Memorandum

Subject: Gasco – U.S. Moorings Area Substantial Product Evaluation

TECHNICAL MEMORANDUM FOR: Chris Budai, Project Manager U.S. Government Moorings

SUBJECT: Summary of Substantial Product in Sediment Cores, U.S. Government Moorings

Table 1
Borings Containing Evidence of "Substantial Product"
 U.S. Moorings Site
 Portland Harbor Superfund Site

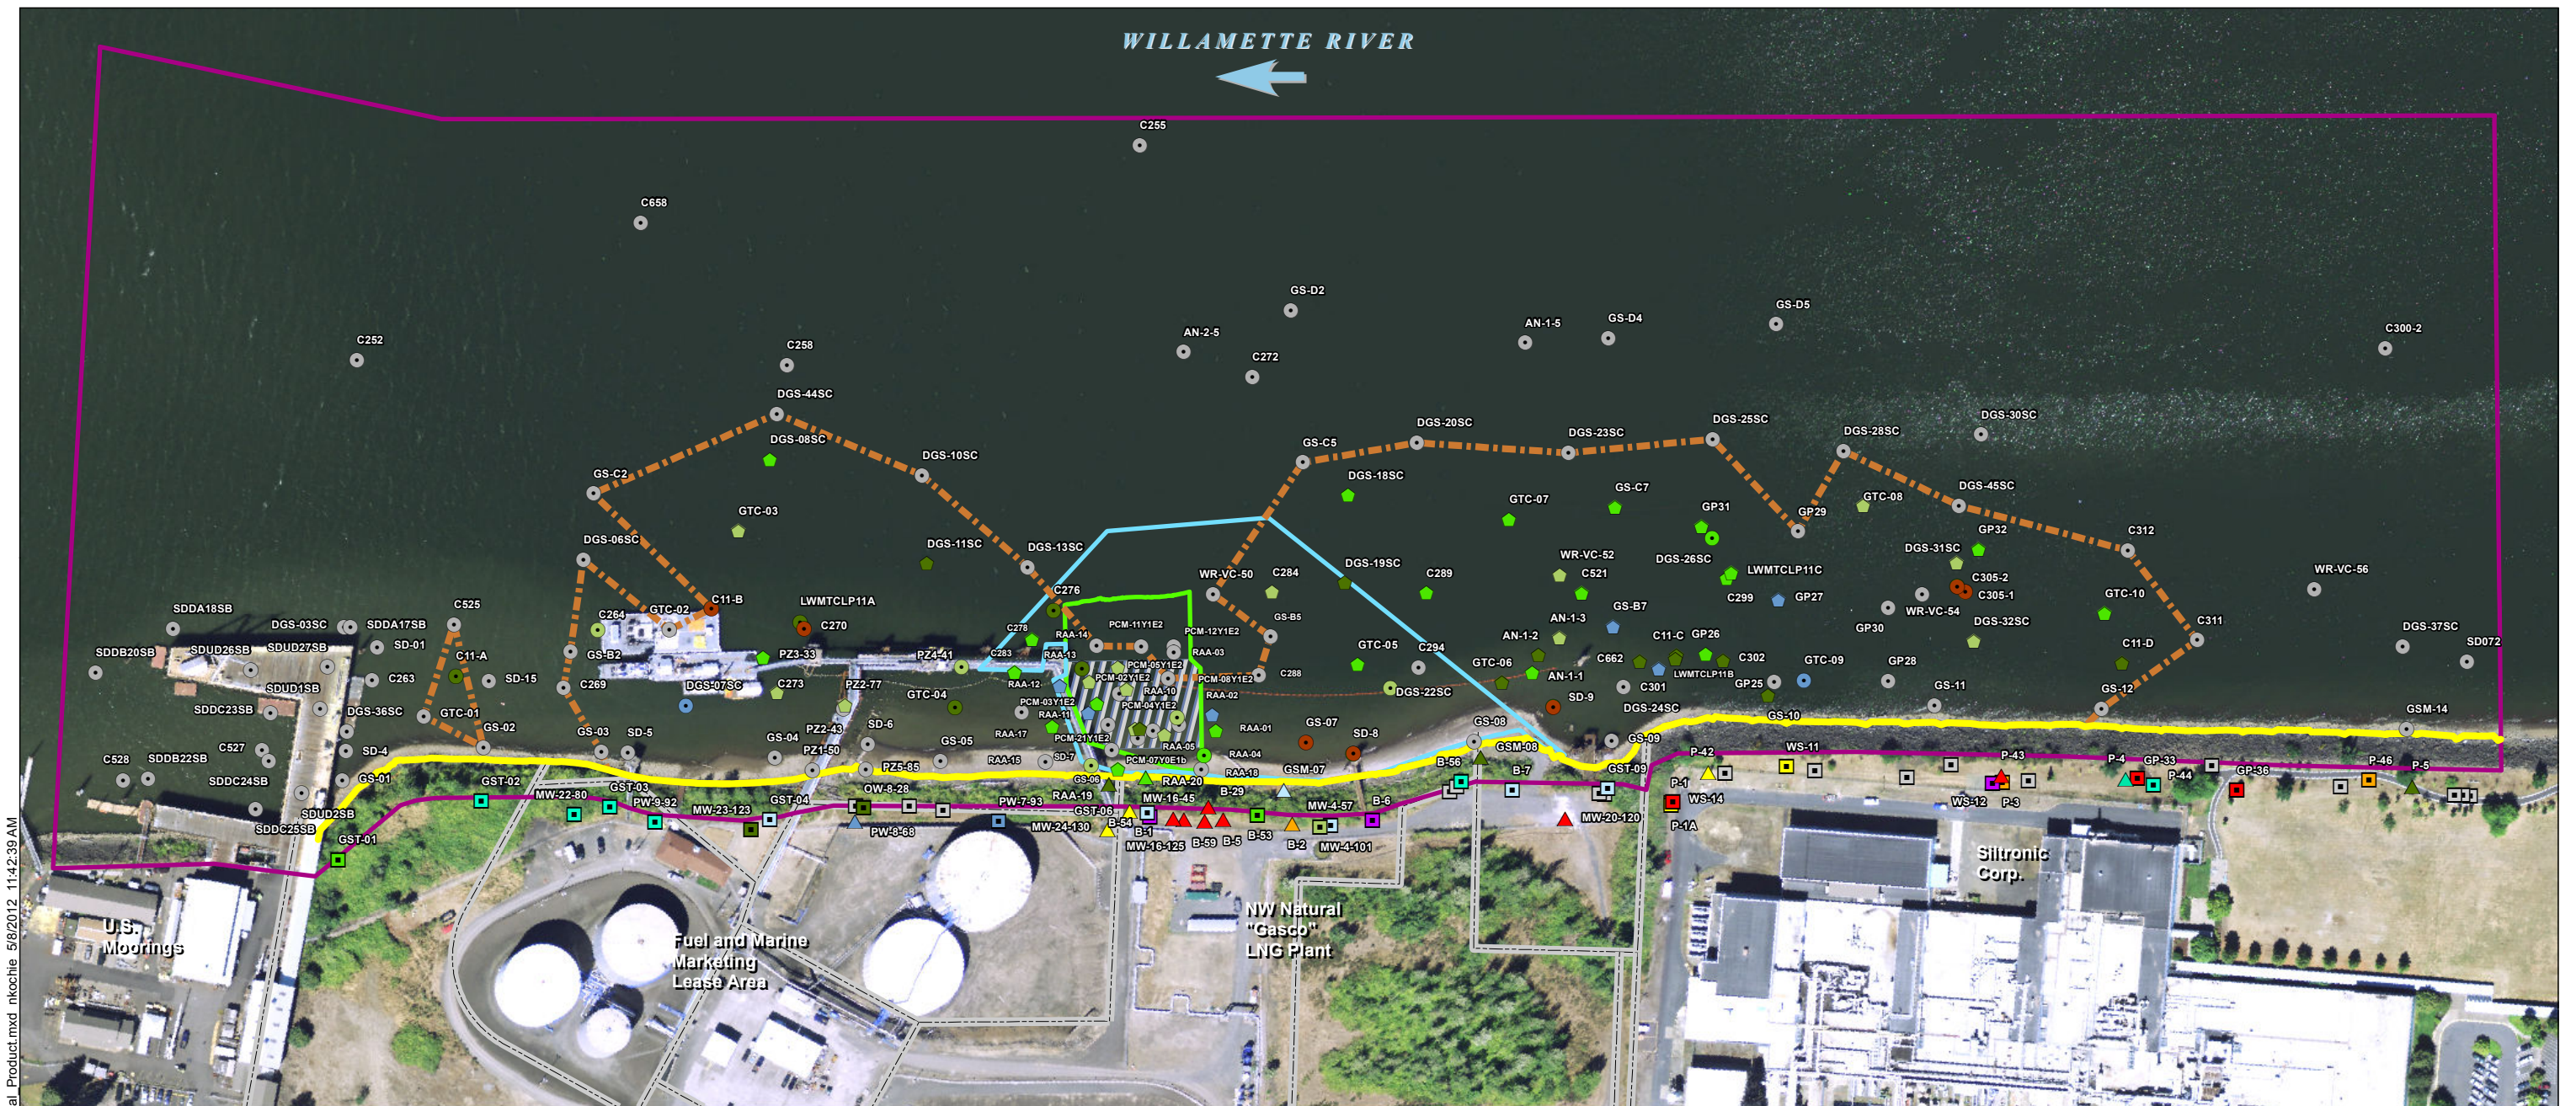
Based on a review of the logs, three core locations were identified as containing substantial product. Two other locations were identified as containing substantial product based on the depth to which future maintenance dredging outside the navigation channel is anticipated to occur. Details regarding the location, depth, thickness of product layers, description, and rationale for the interval being defined as containing substantial product are provided on **Table 1**. The following core locations are identified as containing substantial product based on the depth from the current mudline:

- 50-BG Presence of NAPL at various depth intervals
- GS-01 2-foot thick layer of staining in conjunction with hydrocarbon-like odor within 5 feet of mudline
- SDDA-18 3-inch thick layer of stained sediment with strong odor and sheen within 5 feet of mudline

- 20-BF 2.8-inch thick black layer with strong odor and sheen within 5 feet of mudline after future maintenance dredging outside the navigation channel
- C528 Inconclusive. The log indicates black-stained bands up to 5.5 inches thick occur within the interval from 5.1 to 14.8 feet below the current mudline. Although the log does not specify the exact locations in this interval, some of these bands may be within 5 feet of the mudline after future maintenance dredging outside the navigation channel.

FIGURE 1
SUBSURFACE
SEDIMENT CORE
LOCATIONS

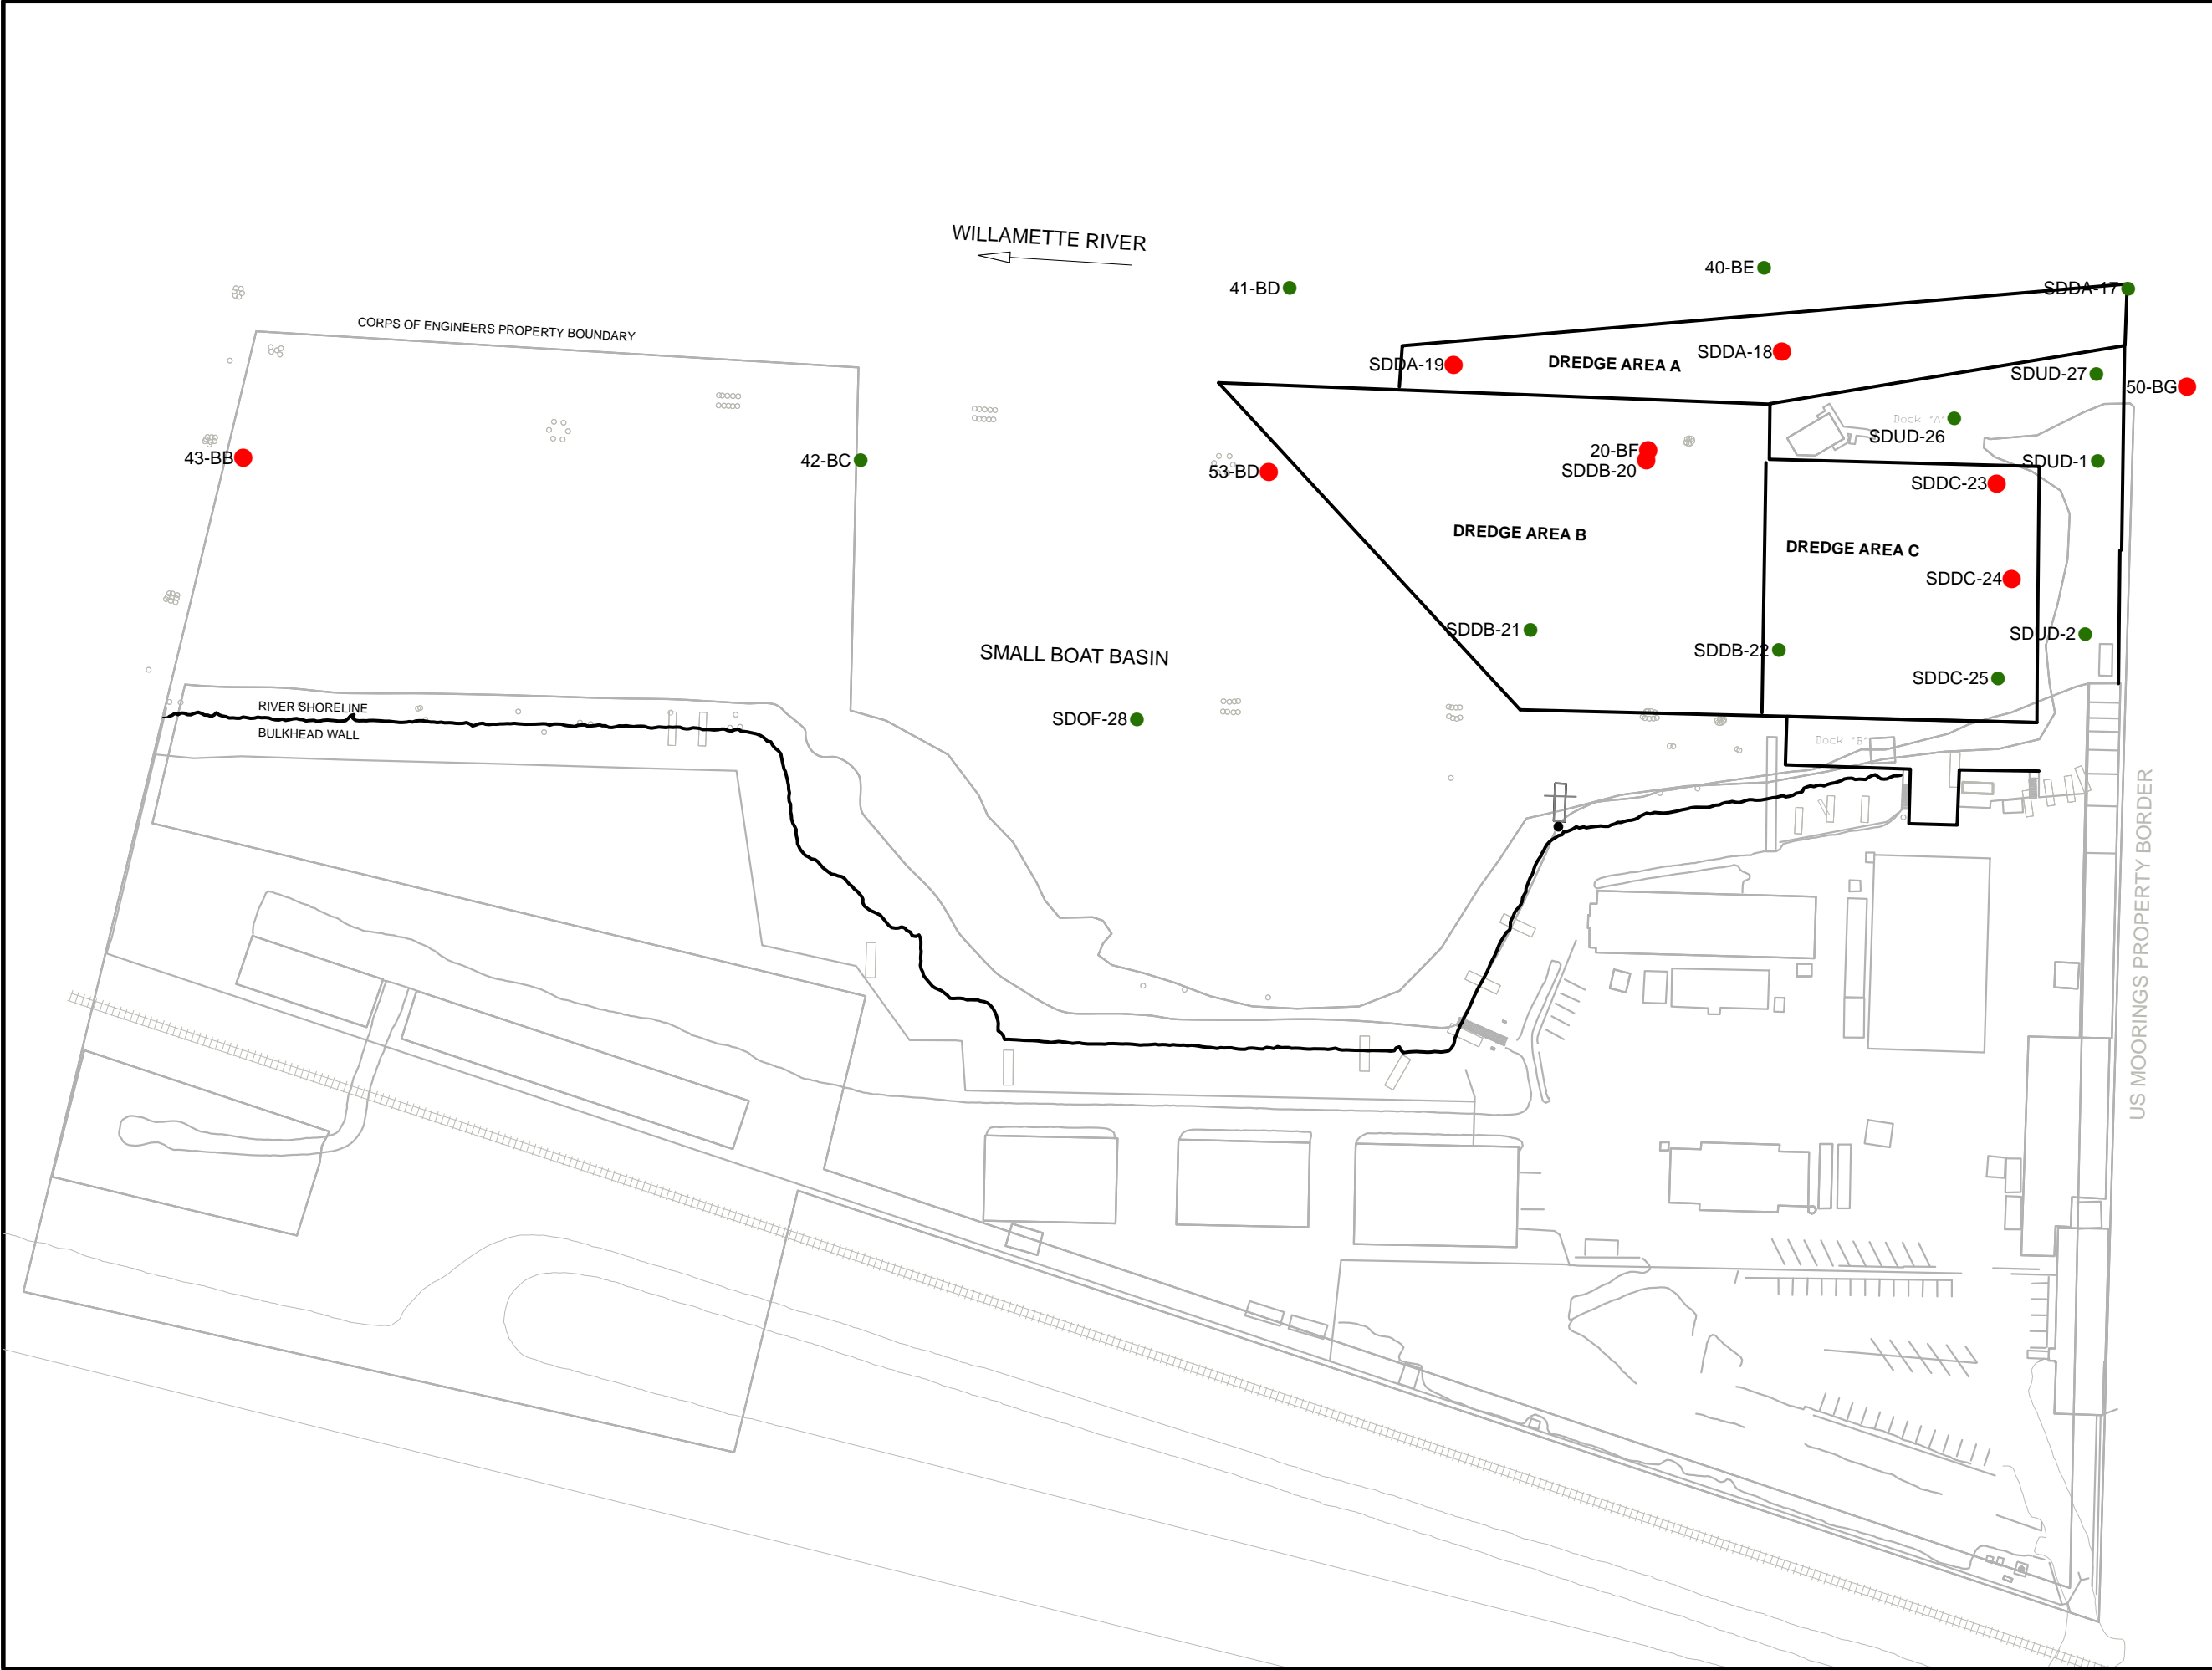
Figure 1 shows the core locations where substantial product was identified. Attachment 1 presents summary core logs highlighting the description that identified the location as containing substantial product. Attachment 2 presents the core photographs with the location of substantial product. For reference, the full core logs from the RI and supplemental investigation are included in Attachment 3.

Figure 1 shows future dredge areas (A, B, and C) that may be designed to expose a clean face or to include sufficient over-depth to accommodate a cap. For the purpose of the RI, the dredge depths were defined assuming a 5-foot cap thickness, including armor and barrier/filter. The depths of water in the berths will be -31 feet Columbia River Datum (CRD) for the Essayons and -19 feet CRD for the Yaquina. Assumed dredge depths are:

The USACE memorandum misidentifies nine cores as containing substantial product. The misidentification is due to incorrectly applied assumptions coupled with the likely bias in the logging terminology. In fact, in Figure 1 of the USACE memorandum, none of the cores shown adjacent to the U.S. Moorings site achieves the visual criteria described in the SOW. Anchor QEA believes that one core station (50-BG) should be designated as inconclusive for substantial product consistent with the Draft EE/CA terminology. The log for station 50-BG identifies “NAPL” in a number of depth intervals but, as noted previously, there are no clarifying descriptors of seams or layers of liquid of such NAPL, nor are they visually present in the core photos. This station is located within the Gasco Sediment Site cleanup area (referred in the USACE memorandum as the Project Area) upstream of the U.S. Moorings dock. The inconclusive designation will be included in the Final EE/CA but will not affect the substantial product or Interim Project Area boundary.

USACE identifies three potential future maintenance dredge areas (FMDs) in Figure 1: FMD A, B, and C. FMDs B and C were not identified during development of the Portland Harbor Superfund Site draft Feasibility Study (FS) and were not available to NW Natural during development of the Draft EE/CA; therefore, these FMDs were not included in the Draft EE/CA. USACE states that the RI assumed dredge depths of 5 feet below the necessary berthing depths in the FMDs to support placement of a 5-foot cap. NW Natural disagrees with this assumption, particularly since USACE has not documented their cap evaluations or provided a design that requires the use of a 5-foot cap (i.e., capping may be effective with caps less than 5 feet thick). Also, the USACE assumption appears to confuse the 5-foot dredge depth requirement noted in the SOW substantial product criteria with an assumed cap depth, which is a separate issue not immediately relevant to substantial product determination. It should also be noted that the use of 5 feet in Criteria #3 in the SOW is applicable to dredging in the navigation channel, and may not be applicable outside the channel where dredge depths and cap designs could be modified to affect depths less than the assumed 5 feet in the SOW. Regardless, NW Natural’s review of the Attachments 1 through 3 of the technical memorandum identifies no substantial product
